## HISTORIC AND DESIGN REVIEW COMMISSION

February 21, 2018

**HDRC CASE NO:** 2018-067  
**ADDRESS:** 427 ADAMS ST  
**LEGAL DESCRIPTION:** NCB 2880 BLK 5 LOT 7&8  
**ZONING:** RM-4, H  
**CITY COUNCIL DIST.:** 1  
**DISTRICT:** King William Historic District  
**APPLICANT:** James Ed Carleton  
**OWNER:** Elaine and Rick Lutton  
**TYPE OF WORK:** Construction of a rear addition  
**APPLICATION RECEIVED:** February 02, 2018  
**60-DAY REVIEW:** April 3, 2018

# 427 Adams

## ***Proposed Rear Elevation***

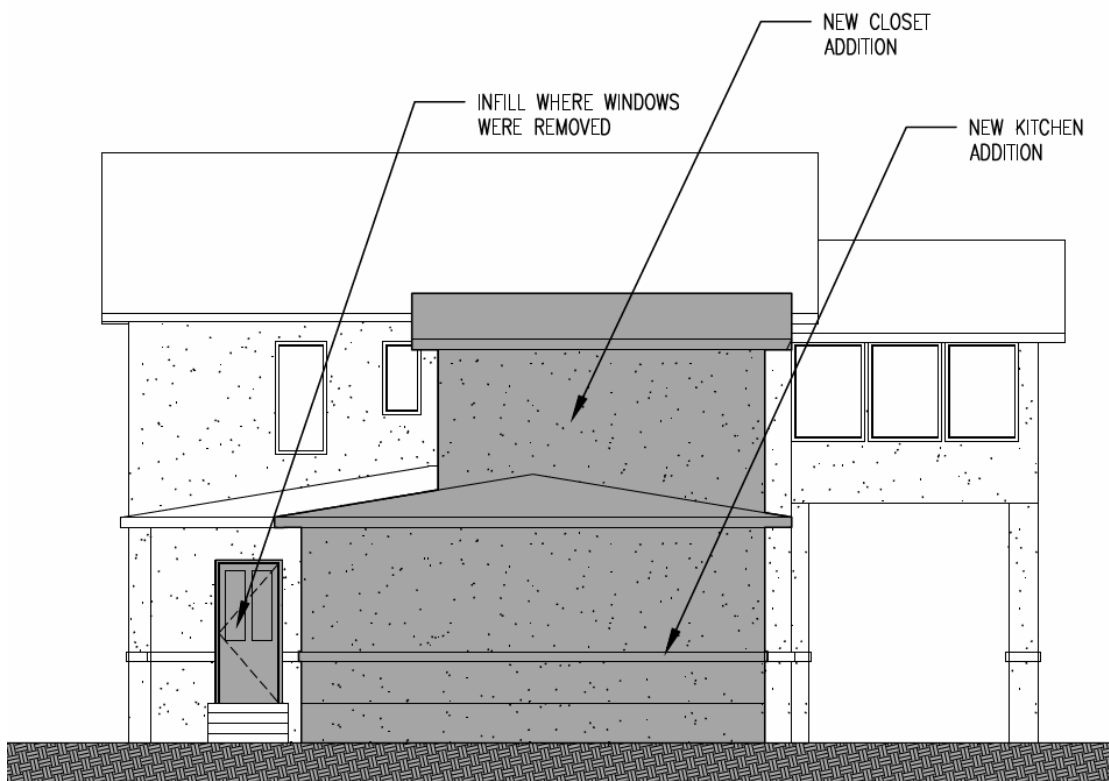
- d. **MATERIALS** – The applicant has proposed materials that include a stucco façade, a standing seam metal roof and wood casement windows. Staff finds that the stucco finish should match that of the primary historic structure. The standing seam metal roof should feature seams that are 1 to 2 inches in height, panels that are 18 to 21 inches in width and a crimped ridge seam. While inconsistent with the Guidelines, staff finds the proposed bronze colored roof to be appropriate given the color of the existing roof.

- f. **ARCHITECTURAL DETAILS** – Generally, the proposed addition is appropriate for the style of the primary historic structure and consistent with the Guidelines. Prior to returning for final approval, the applicant should provide additional information regarding window profiles and exterior elevations of each side of the proposed structure.

- i. That the proposed standing seam metal roof features seams that are 1 to 2 inches in height, panels that are 18 to 21 inches in height and a crimped ridge seam.
- ii. That the proposed stucco finish matches that of the primary historic structure.
- iii. That one over one wood windows be installed that feature specifications noted in finding e.
- iv. That elevations of each of the addition’s facades be submitted when returning for final approval.
- v. That the removed wood window be salvaged and installed in the proposed addition.

1 FIRST FLOOR DEMOLITION PLAN  
1/4"=1'-0"

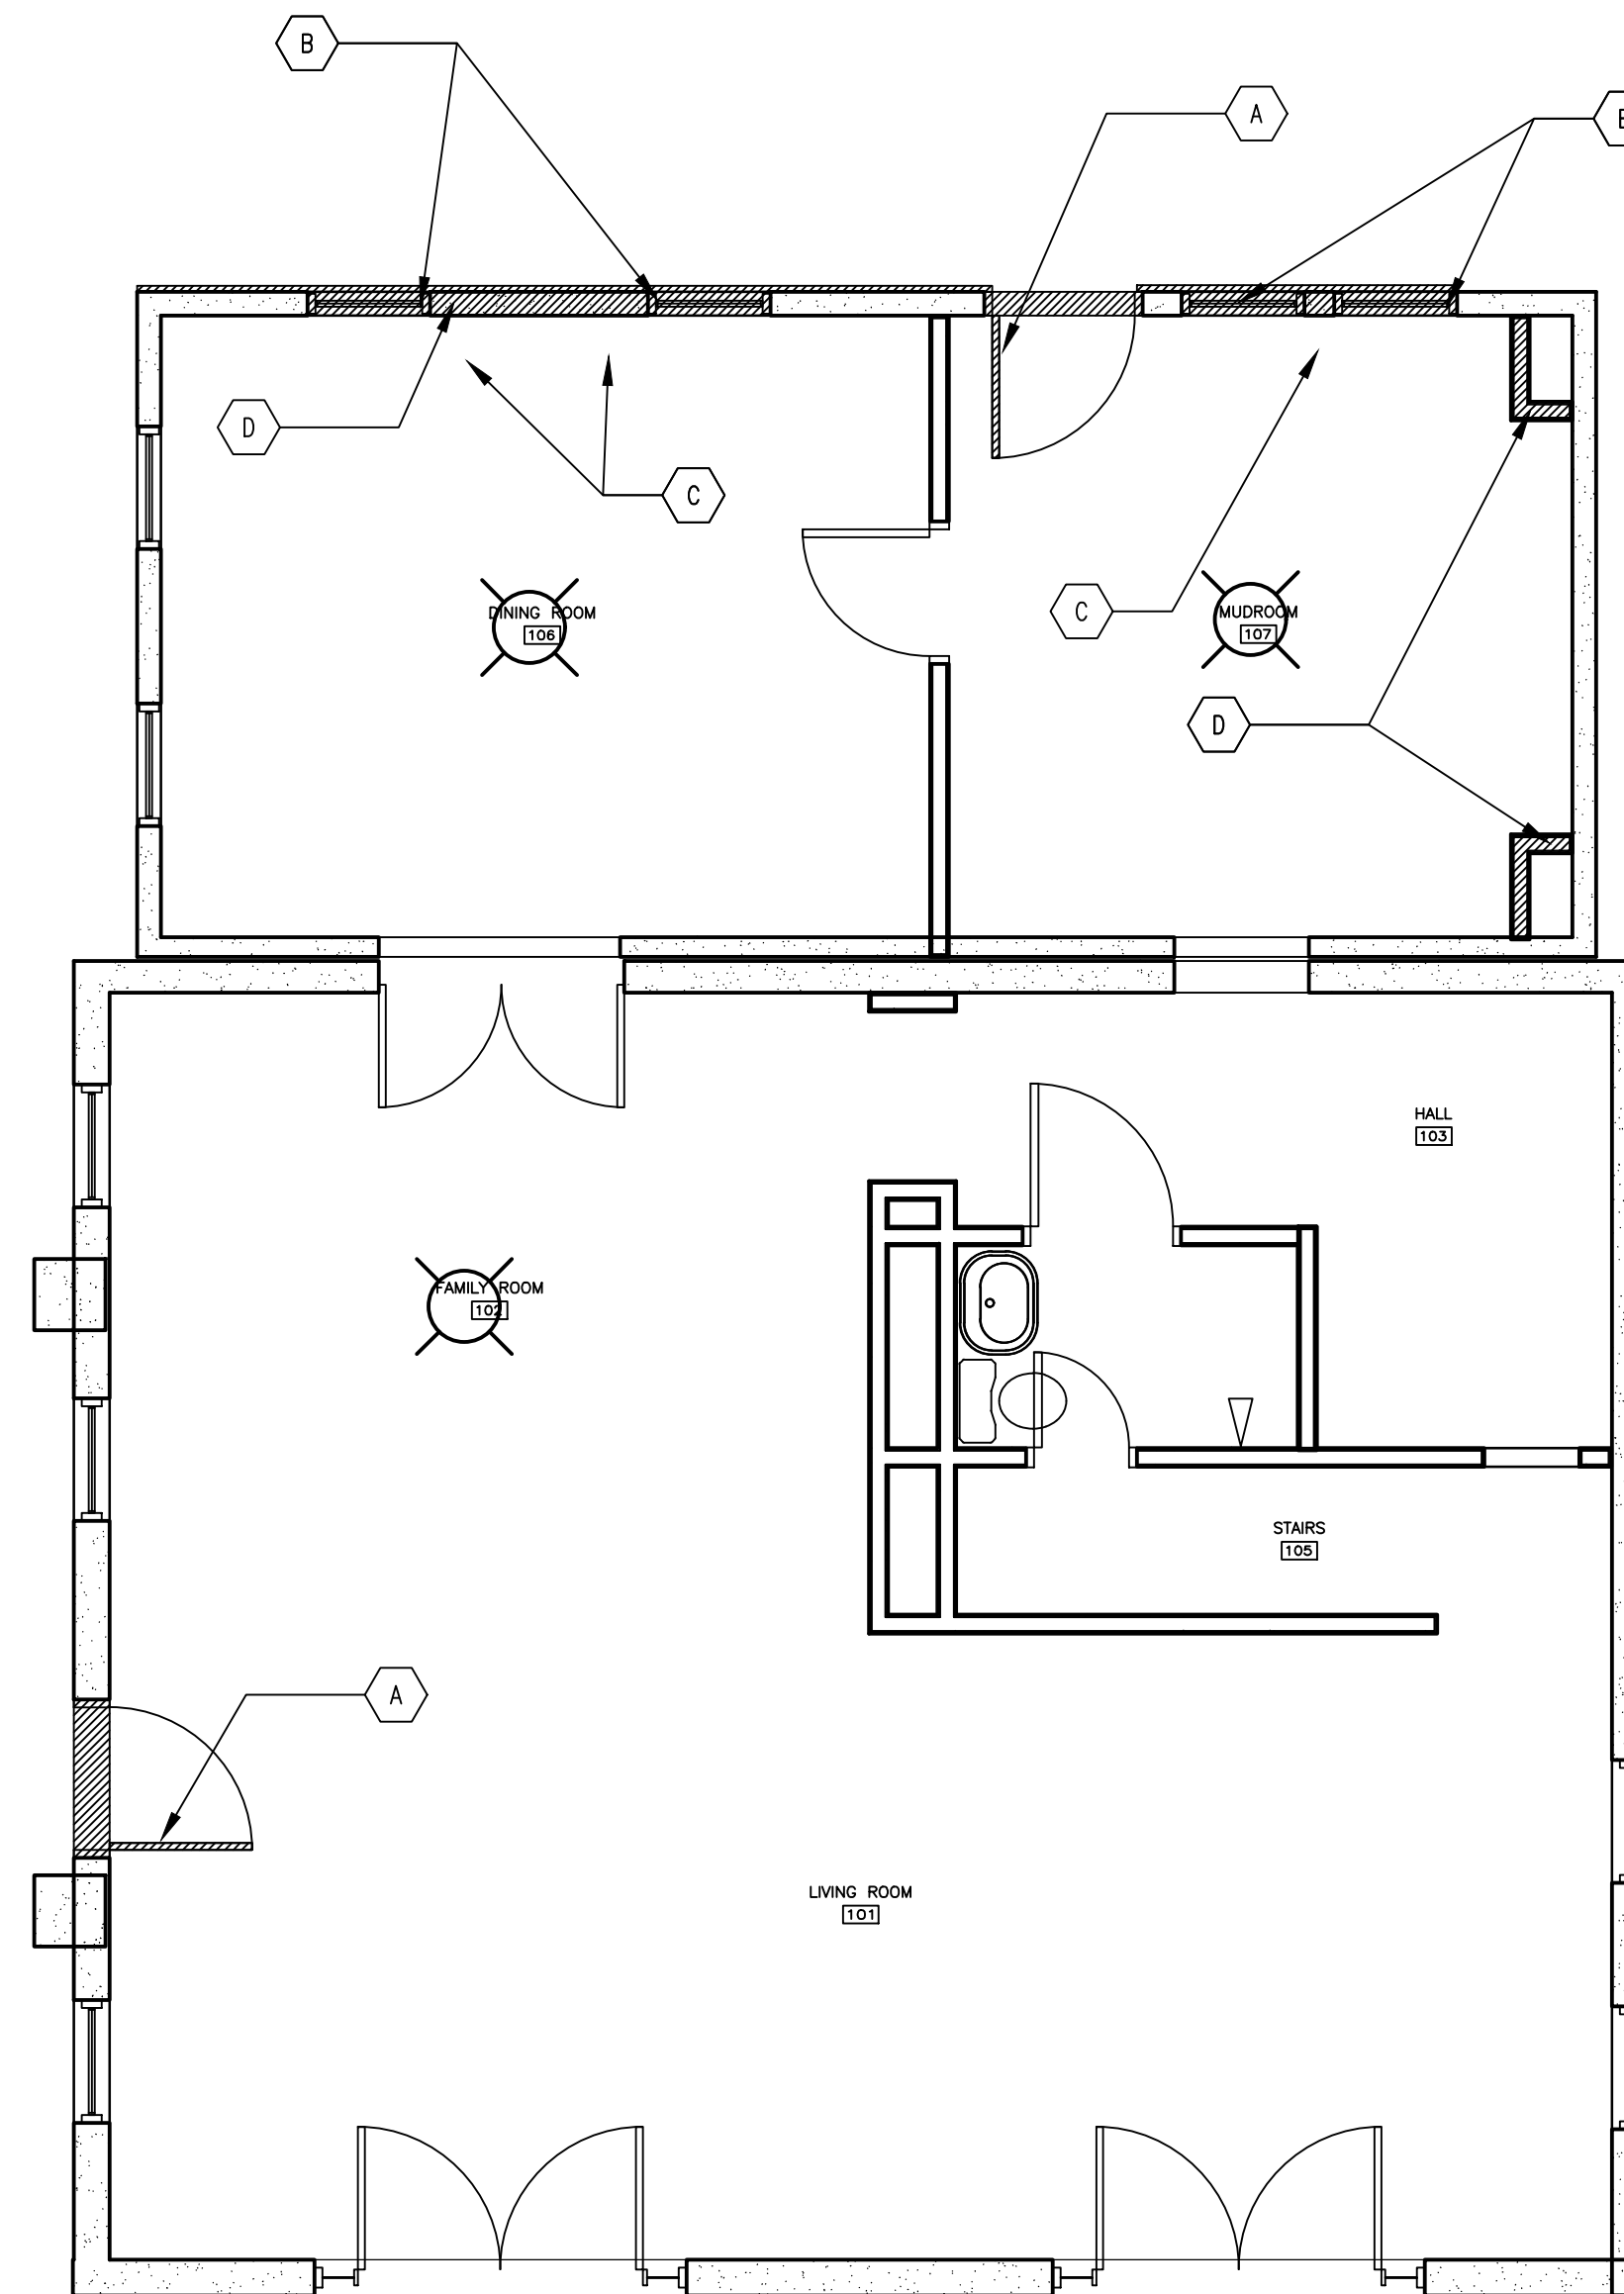
- g. **WINDOW REMOVAL** – To the immediate rear of the side porte cochere, the applicant has proposed to infill an existing window opening. The Guidelines for Exterior Maintenance and Alterations 6.A.i. notes that existing window and door openings should be preserved. The applicant’s proposed window removal is not consistent with the Guidelines; however, given its location and low visibility due to the existing porte cochere, staff finds that its removal may be appropriate if the existing window is repaired and installed in the proposed addition.

- h. **DOOR REMOVAL** – Beneath the porte cochere the applicant has proposed to remove an existing door opening. The Guidelines for Exterior Maintenance and Alterations 6.A.i. notes that existing window and door openings should be preserved. The applicant’s proposed door removal is inconsistent with the Guidelines. This door, serving as a historic side entrance location contributes significantly to the architectural integrity of the structure and the historic use of the porte cochere.

Staff does not recommend approval of item #4, door removal based on finding h.
